MIL-M-49241A(CR)
AMENDMENT 1
2 October 1992

MILITARY SPECIFICATION
MULTIPLEXER, TD-1236/G

FIGURE 18. False frame lock.

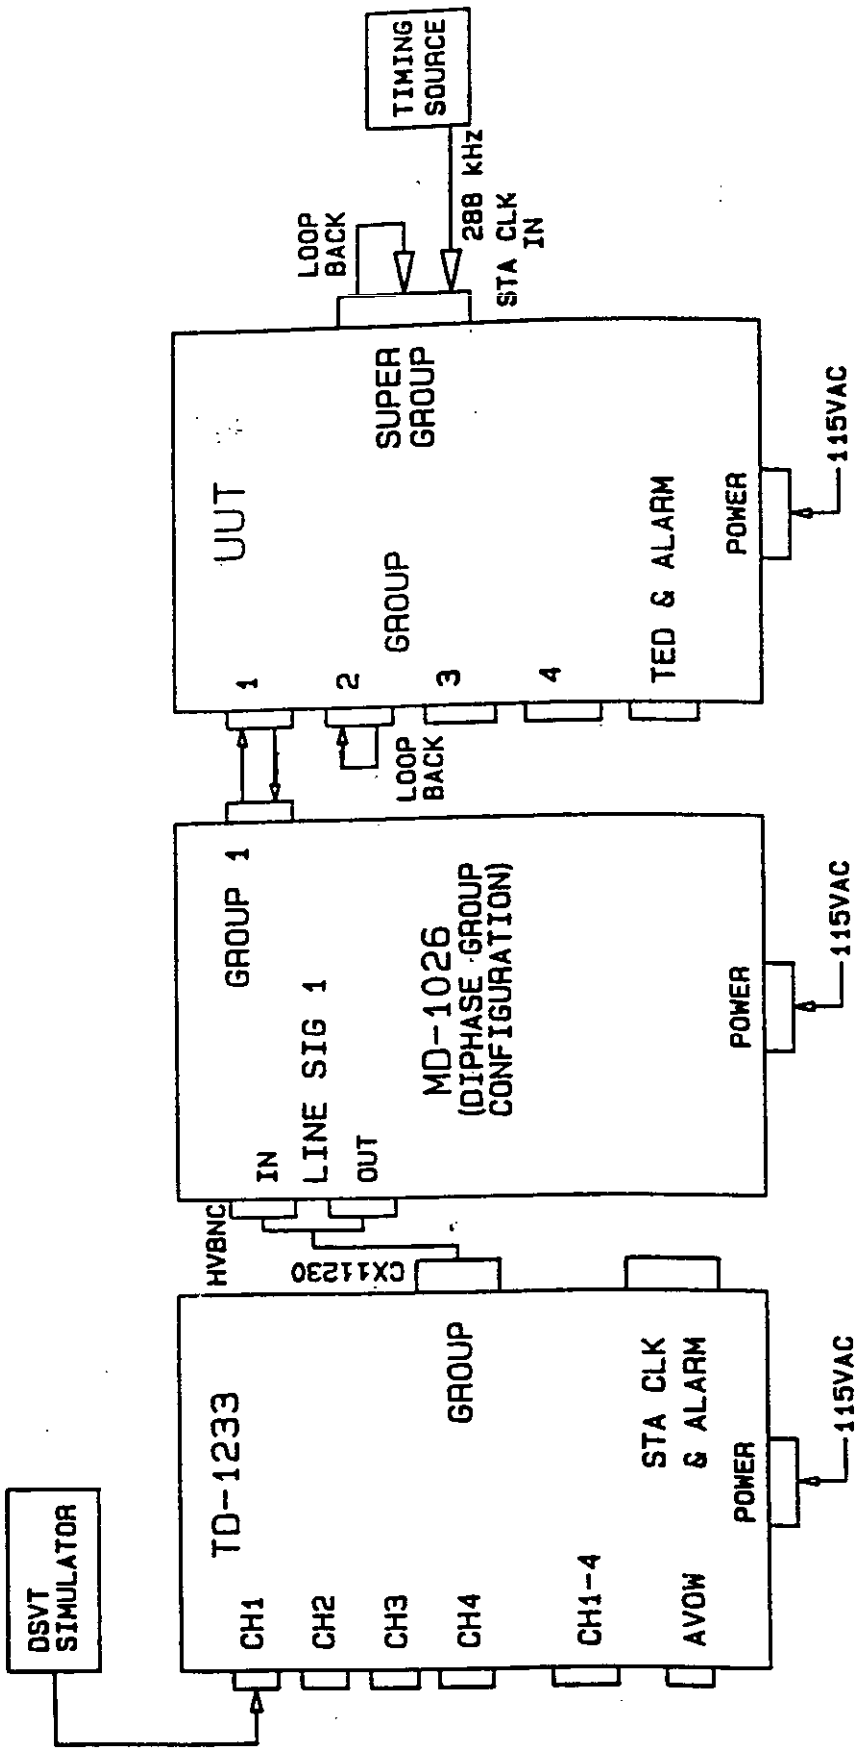
Delete Figure 18 and substitute with the accompaying figure.
